Technical Service Bulletin

GROUP	NUMBER
CAMPAIGN	14-01-042
DATE	MODEL(S)
OCTOBER 2014	EQUUS (VI)

SUBJECT: LEFT AND RIGHT REAR DOOR CURTAIN ECU REPLACEMENT
(SERVICE CAMPAIGN TU4)

Description: This bulletin provides a service procedure to replace the rear door curtain ECU. Certain vehicles may exhibit a condition where the rear door curtains will not roll up or down.

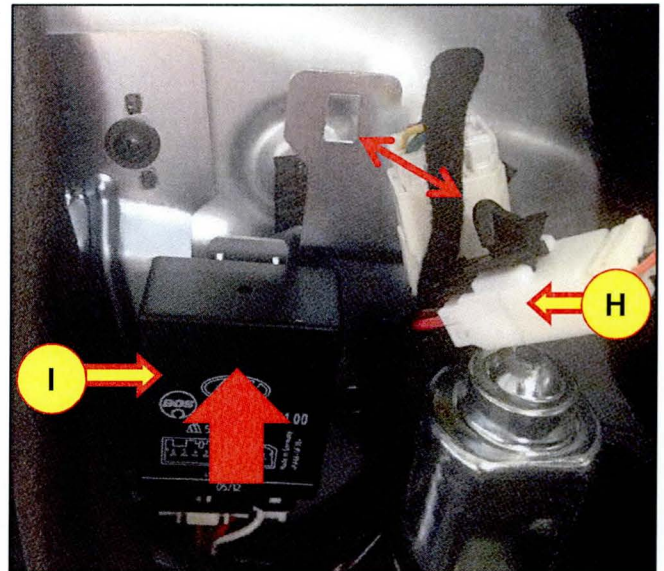
Remove the rear door curtain ECU (I) by sliding it upward as shown in the directional arrow.

10. Install the new ECU (K) in reverse of removal.

Confirm the part number and S/W version of the new ECU.

PART ID	S/W VER.
PREVIOUS	9 935 4 00001 <u>01</u> (Rear Driver and Passenger Side)	V <u>2.00</u>
NEW	9 935 4 00001 <u>02</u> (Rear Driver and Passenger Side)	V <u>3.00</u>

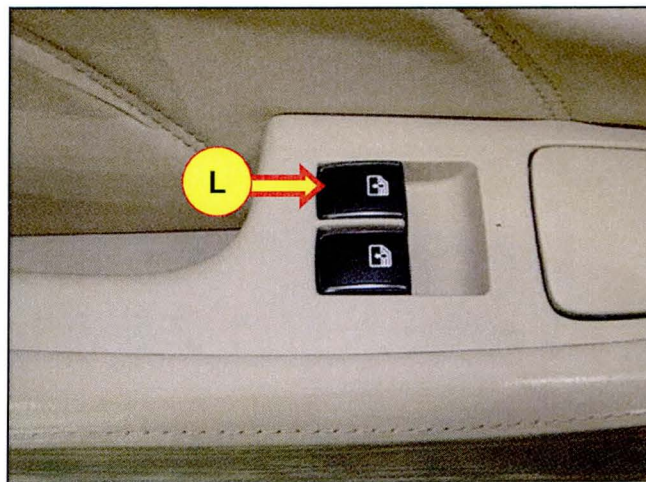
11. Initiate the rear driver side door curtain ECU as follows:

- 1) Lift the switch (L) to partially expand it.
- 2) Press the switch (L) to completely fold it.
- 3) Lift the switch (L) to fully expand it.

12. Repeat same procedure above for the rear passenger side door.
